**Design Review Committee
September 26, 2013**

SUBJECT: Case 18707: Substantive Site Plan Approval – Mixed-Use
Development, 1581 Dresden Row, Halifax

SUPPLEMENTARY REPORT

A100 SITE PLAN

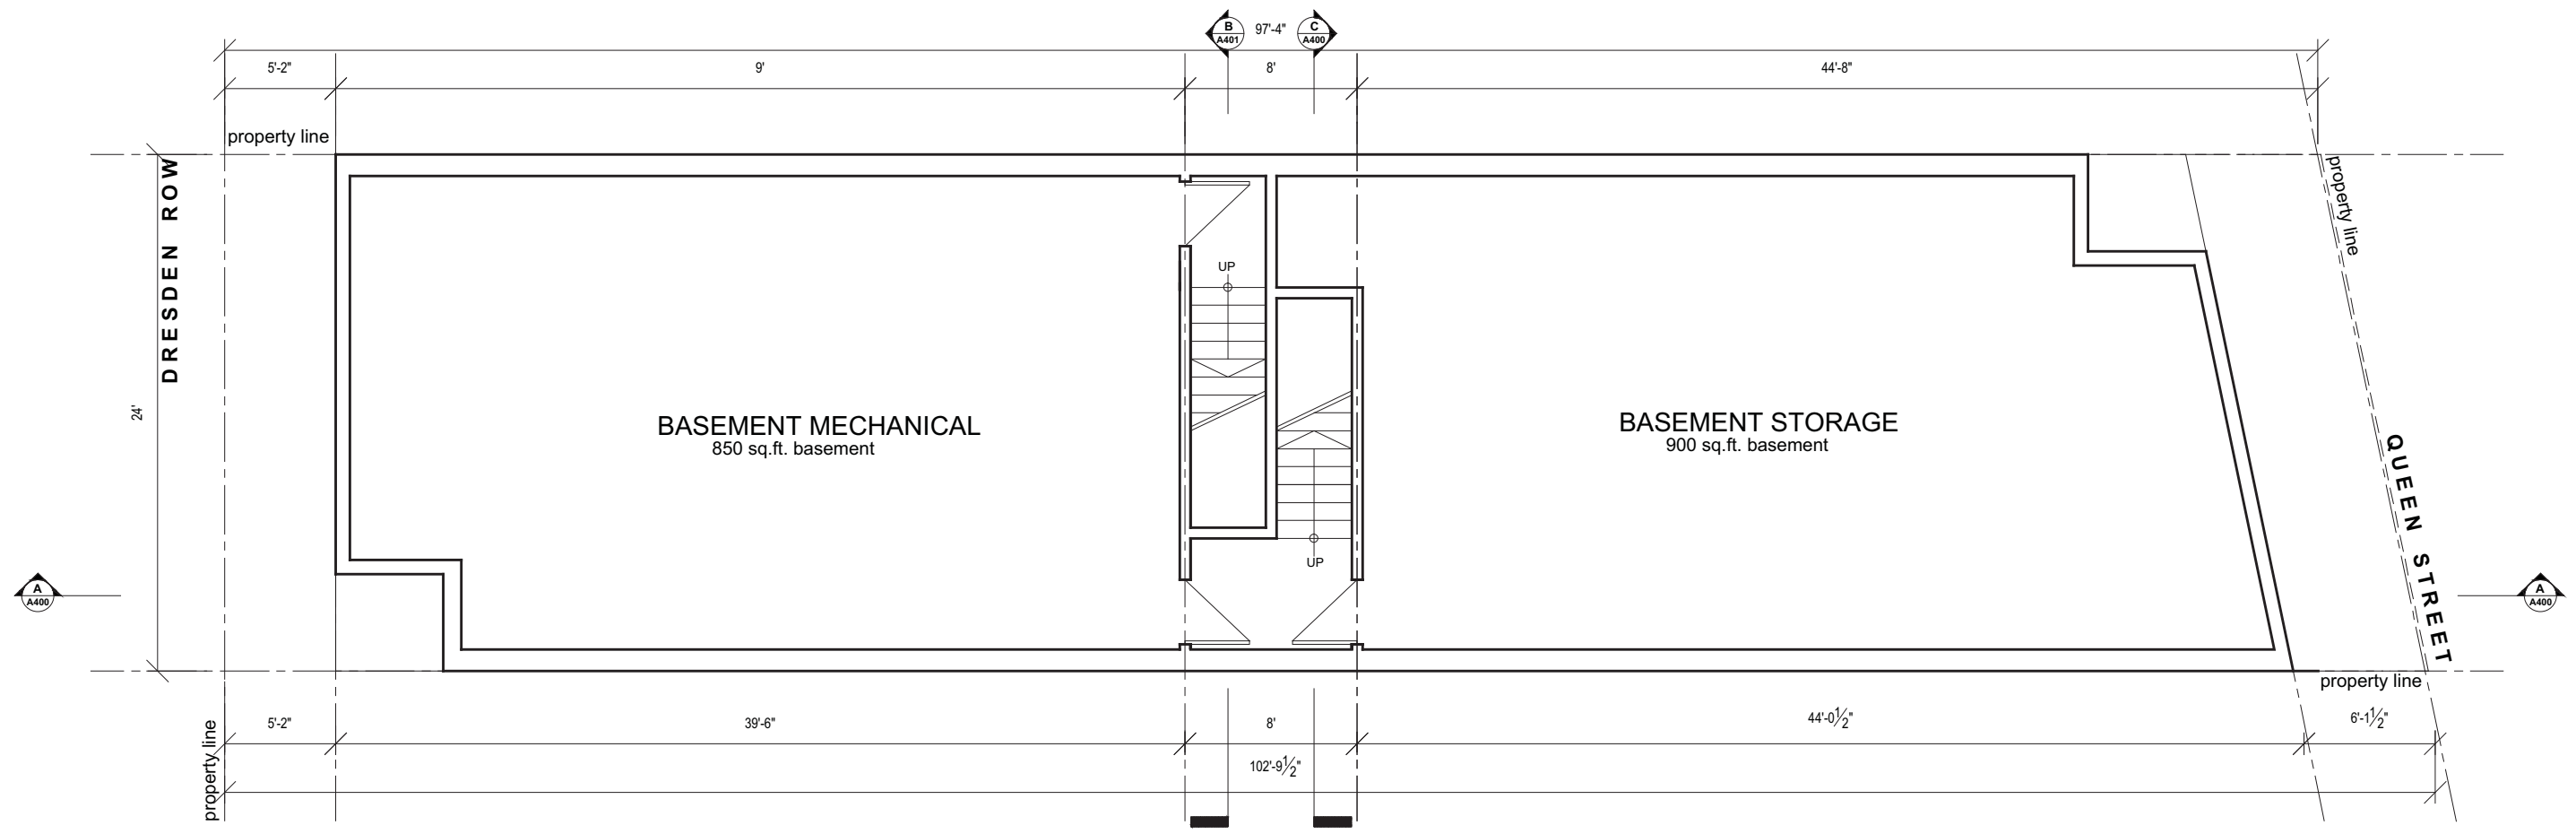
- Details on the architectural elements of the building, including revised Site and Floor Plans;
- Elevation Plans including details on the following:
 - Residential and commercial uses at the ground level on Dresden Row and Queen Street;
 - Design elements of building facades on Dresden Row and Queen Street;
 - Privacy measures for the residential unit on Queen Street;
 - Building materials used (DRC requested physical samples of certain materials);
 - 12-inch parapet to be shown on the plans;
- Landscaping Plan/Rooftop Plan to include details such as planters, benches and shrubs; and
- Detailed Section Plans showing the design of the scissor-style stair well.

- New Site and Basement Level Plans with greater detail and information (Plans A100/A200);
- New Main Level (A201) and Elevation Plans (A300 and A301) with information addressing façade treatments, privacy measures and design elements for both of the proposed ground level commercial fronting on Dresden Row and the residential unit fronting on Queen Street;
- New Elevation Plans (A300 and A301) clearly identifying the 12-inch parapet; and
- New Landscape/Rooftop Plan (A203).
